Submission from Richard Jones

25 February 2021

The Northern Beaches Tunnel project will have a significant impact on the local community and none more so than those in the direct vicinity of the construction zone and tunnel areas, including my family home at 84 Kirkwood Street, Seaforth.

BEACHES TUNNEL RESPONSE

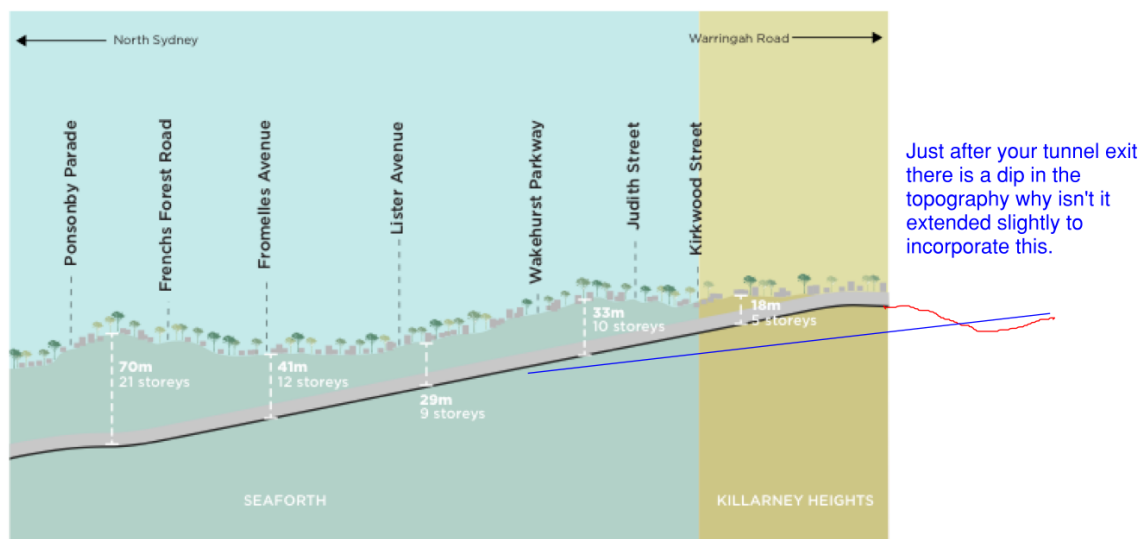
Approximately 150m to the north of where I believe that the tunnel will exit on the Wakehurst PKY there is a decline in the road. Has it been investigated to utilize this?

The benefits would be

- decreasing the incline of the whole tunnel from middle harbour
- reducing emissions
- move the tunnel further north resulting in less impact on the community

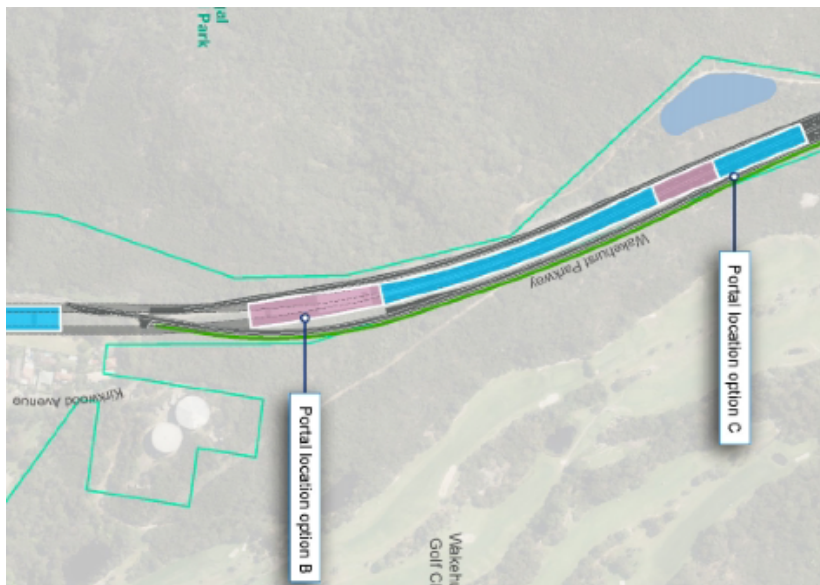
P4-47 The evaluation to choose portal B over portal C was purely a cost saving exercise at the expense of the local community. As a resident from Frenches Forrest was quoted as saying in the Manly Daily "The Warringah Rd project was a living hell for 5 years", this project will be bigger and longer, and RMS could have moved the tunnel entrance 200m further north and BL12 north of BL13 mitigating Kirkwood St resident's exposure.

Figure 5-12 Indicative vertical alignment of the ramp tunnel connection to the Wakehurst Parkway

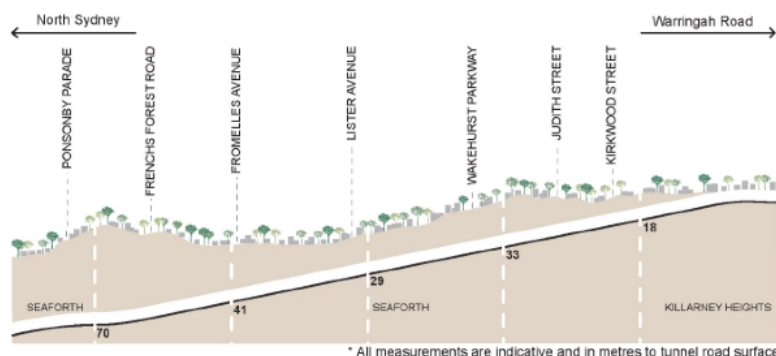
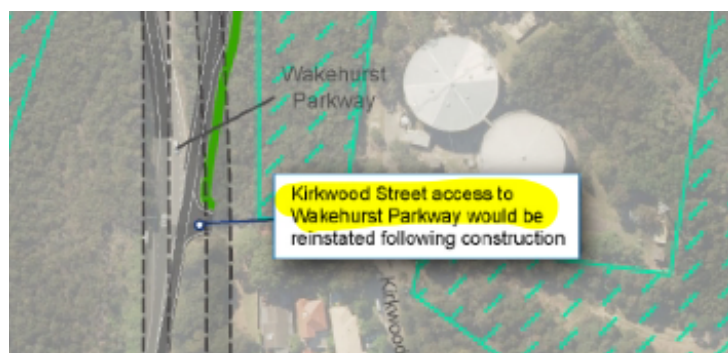
P20 Where are the lateral dimensions and can we have the portals and emission stacks shown on the drawing? The vertical dimension show the tunnel at 23m below my house is this correct?

BL 12

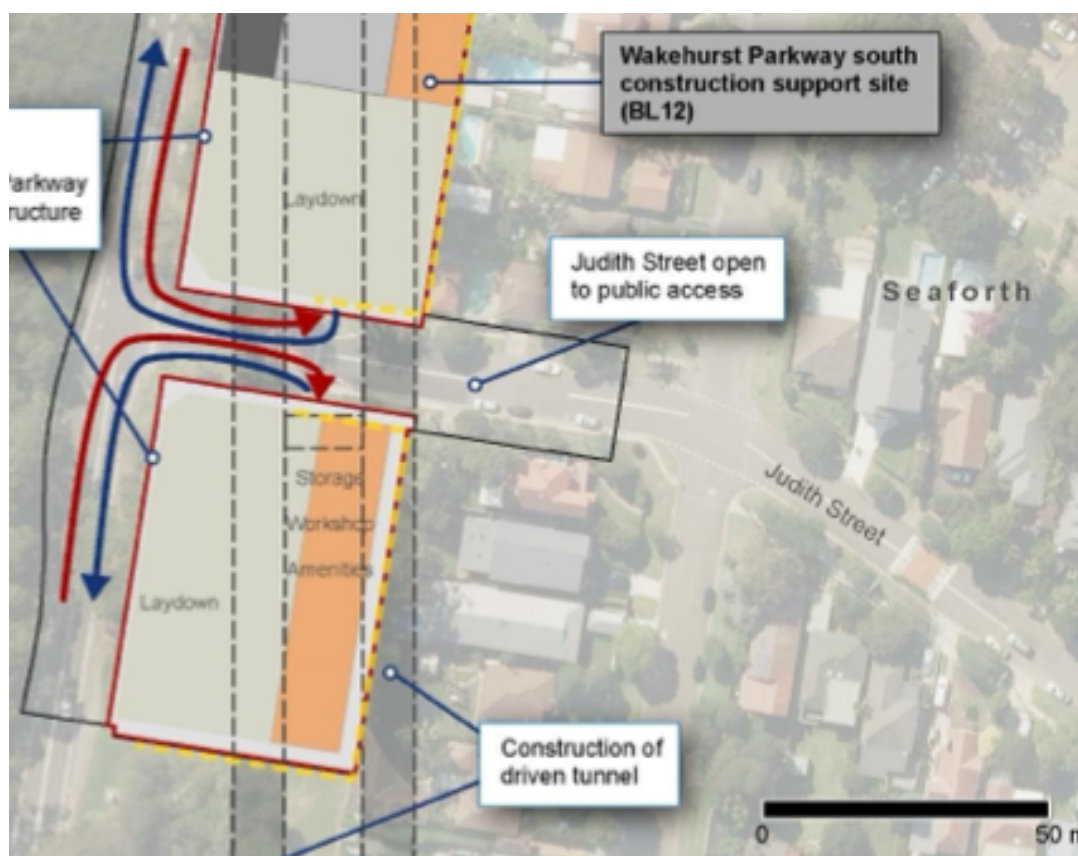
P6-49 As we are close to the emissions exhaust stacks, I’m very concerned about the air quality I will be exposed to in the future. Could you possibly tell me how far it is from my front door to the stacks as the diagram has no scale

- During the community online information session Tim from TNSW repeatedly said its used for storage of bollards and barriers.is this correct?
- Do you have details of the regrade?
- How many car spaces are being made?
- How many workers do you envisage using BL 12&13 at its peak as I want to get an idea of how many workers will be parking on our streets?
- Typically, the parking is only for office staff is that the case here?
- Can you confirm that there will be no double height sheds along our back fences as they will cause privacy issues.

I have heard that there is no left turn from Judith St to the Wakehurst parkway. Your diagram shows a left turn or is that only for the RMS-TNSW

• Judith Street and Kirkwood Street, Seaforth

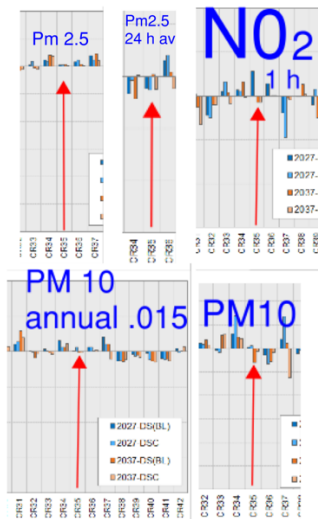
Can we have the predicted modelling data for north Kirkwood St as CR35, Alto Avenue is too far away from our residences to truly reflect the air we may breathe once the tunnel is operational?

Figure 20-5 Land use and zoning – Seaforth to Frenchs Forest

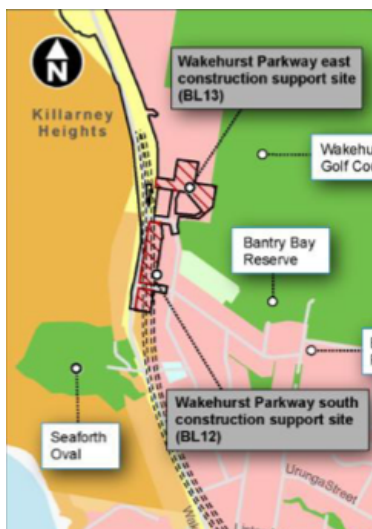
P20-13 Why isn't BL12 north mentioned for any land use?

P20-15 Again BL12 north is not listed as a construction support site is this correct? It's very good news.

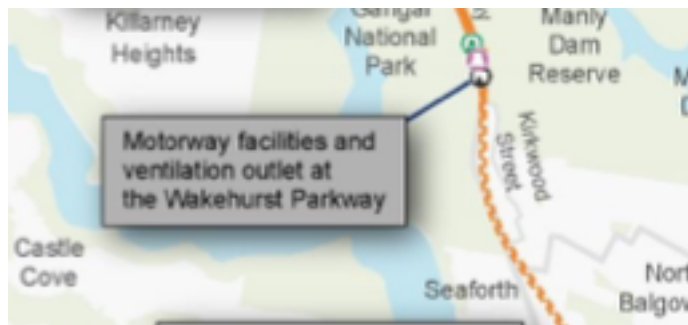
P28-6 This diagram shows a permanent motorway facility at BL13. Is this the case as in Chapter 22 it said it will be South of Seaforth Oval. Is there a detailed drawing of this facility and its location? What are the hours of operation of this facility? Will it service the tunnel during maintenance shutdowns and if so, how often? I know these shut downs are very noisy with numerous trucks and reversing quackers going all night.
